**ARCHITECT'S ADDENDUM**

Addendum Number: 03

Transportation Center

Subject: Addendum No. 03 to the Construction Documents for the Fort Zumwalt School District Transportation Center

**C3**

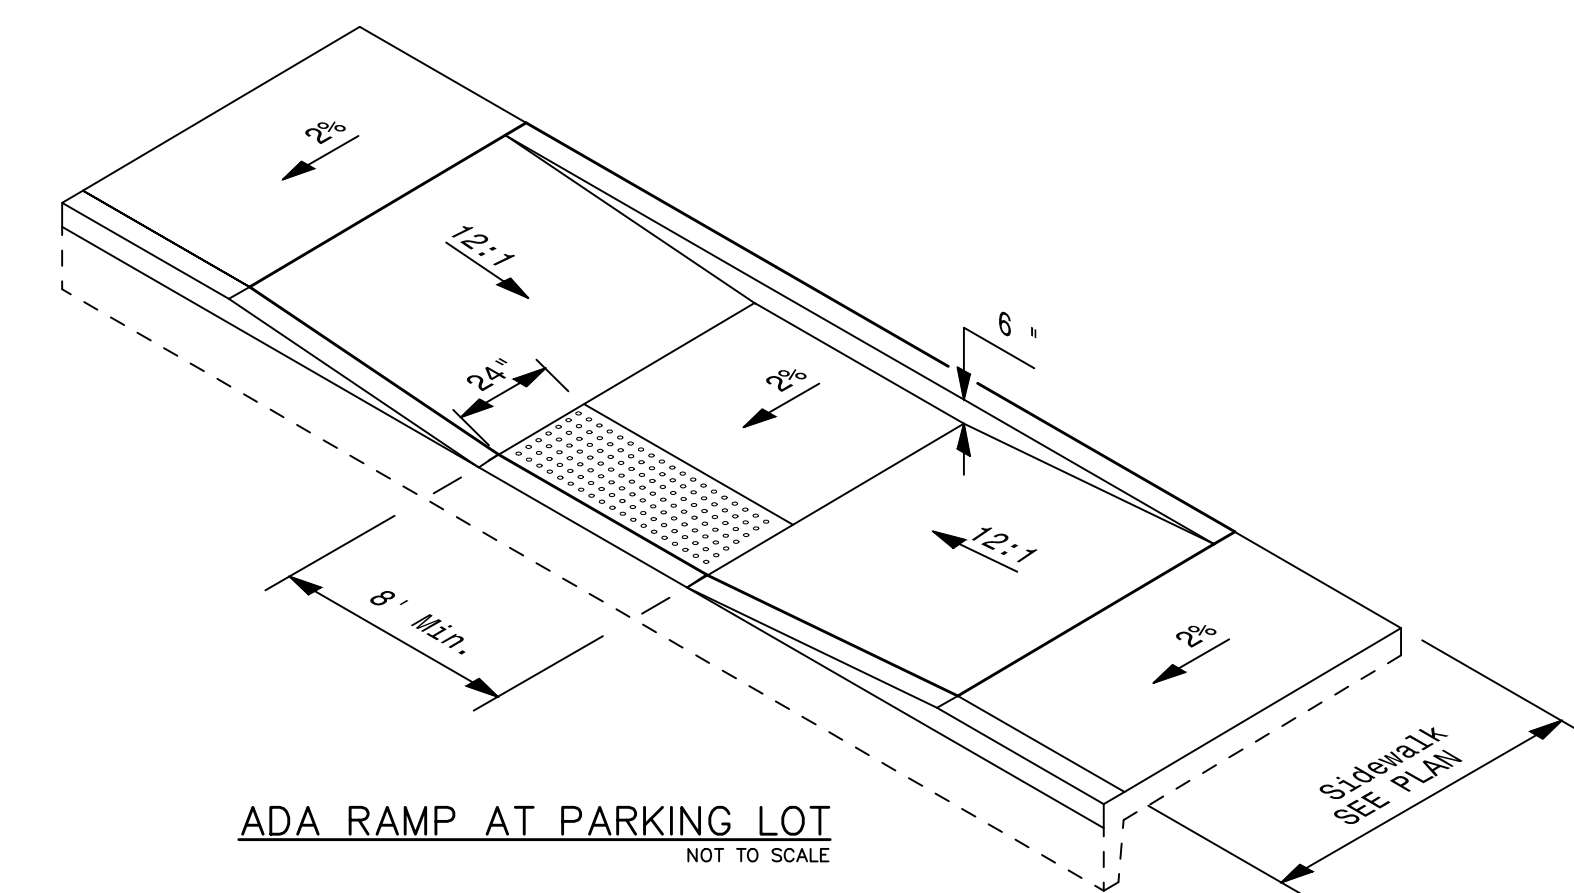
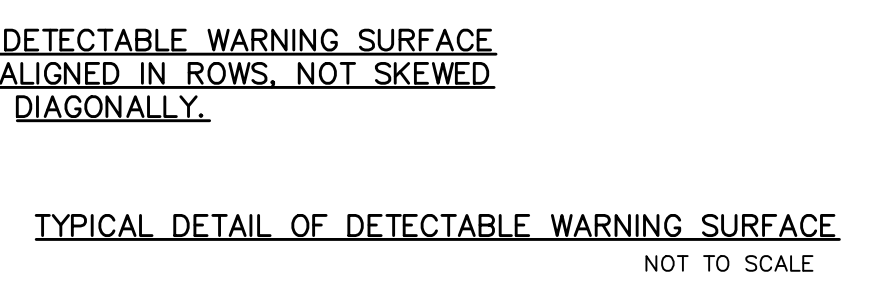
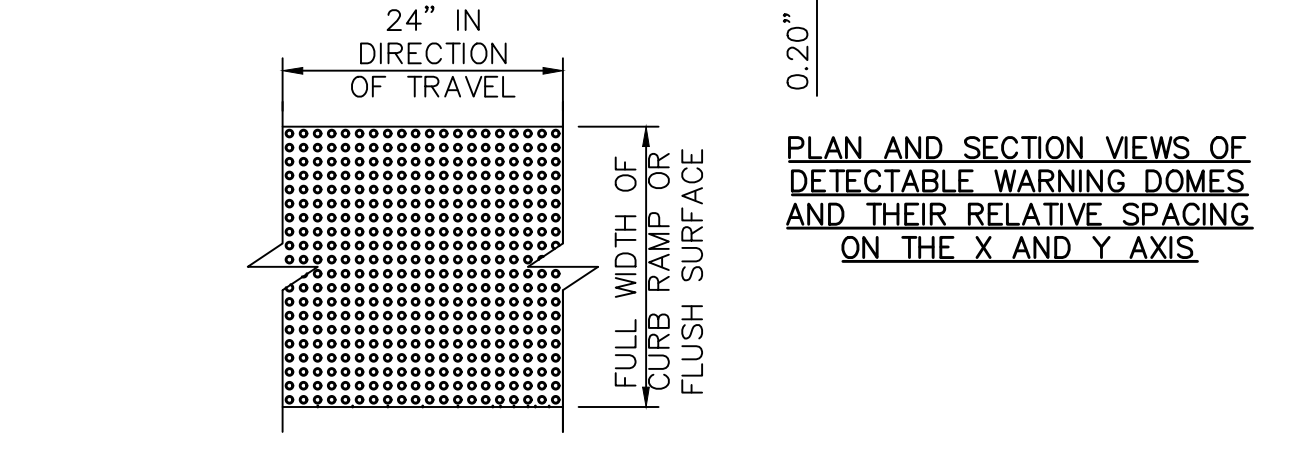
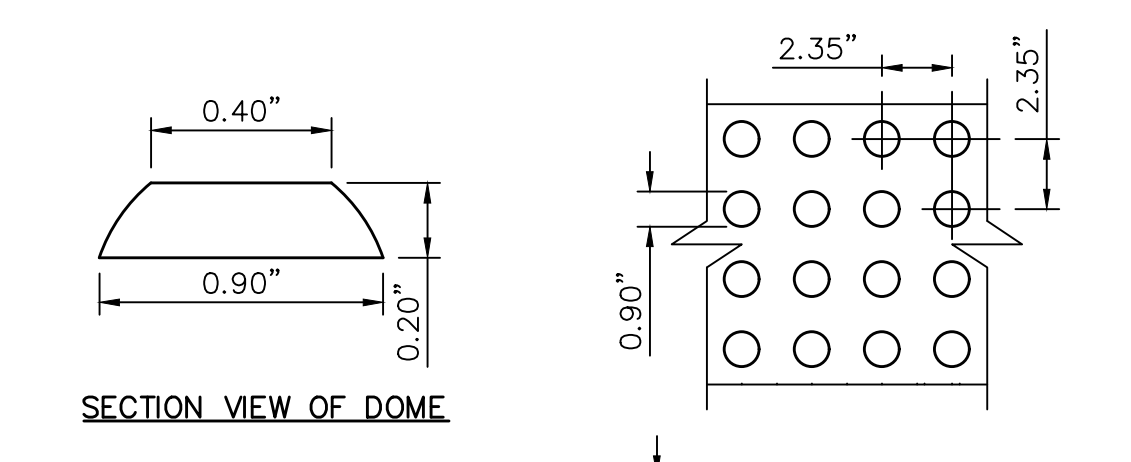
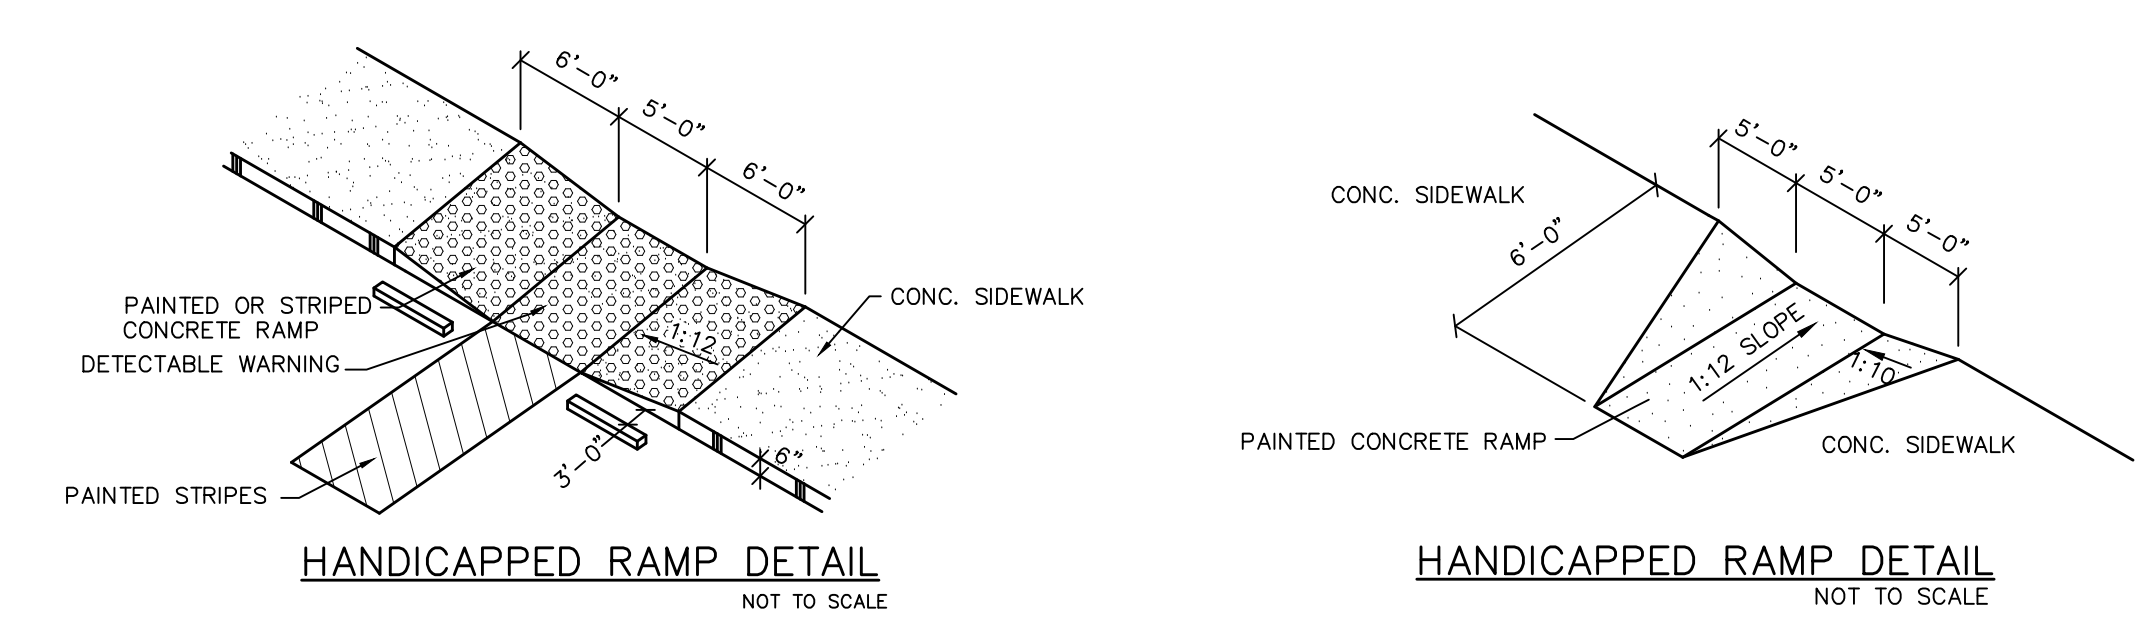
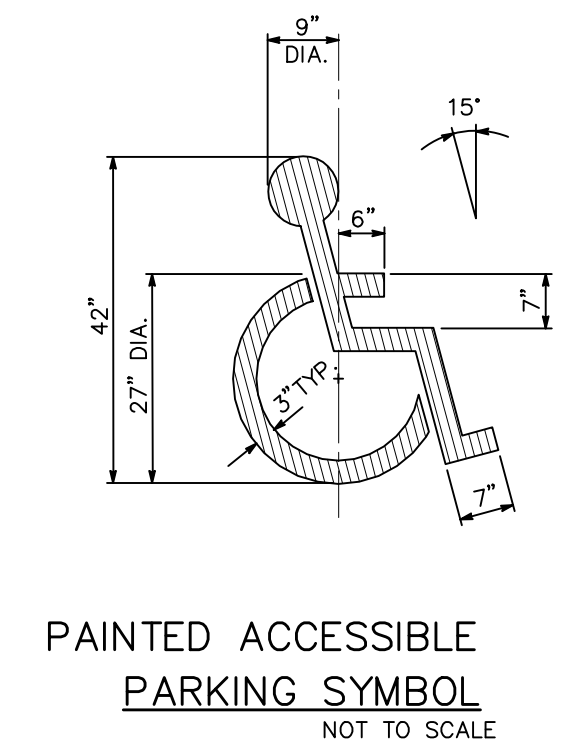
Q - A0.02 shows a Knox Box at only the north emergency access gate. C3 shows a Knox Box at the north emergency access gate and the west slide access gate. Which is correct?

Q - Is a detail available for the "3' Rock Strip for Infiltration" shown on C3? Need to know rock size / type, depth, fabric, etc.

1. C3
  - a. Removed 3’ Rock Infiltration Strip callout
  - b. Added wheel stops to spaces along sidewalk
  - c. Modified number of curb cuts, added riprap at curb cuts
  - d. Added vertical curb near dumpster area
  - e. Revised callout of “Knox Box” at bus drive slide gate to “Gate Code Access Panel”
2. C5
  - a. Revised grading at Rain Garden Area A.
3. C9
  - a. Added wheel stop detail
4. C10
  - a. Revised Rain Garden details, added detail for Filtration Strip Seed Mix and Rain Garden Soil Mix
5. A2.01
  - a. Add bollards to south side of Service Bays 140 at overhead doors.
6. A3.01
  - a. Revise ceilings in rooms Staff Break 135 and Mechanic Break Room 150 to be ACT-1.
7. A5.01
  - a. Add bollards at overhead doors to South Building Elevation 3/A5.01.
8. A10.01
  - a. Revise Material General Finish Notes 6, 8, and 9 to correct paint colors.

A- *Slide gate would only need for the fire dept. to have the access code. See revised drawing this addendum.*

A - *See revised Civil sheets this addendum*
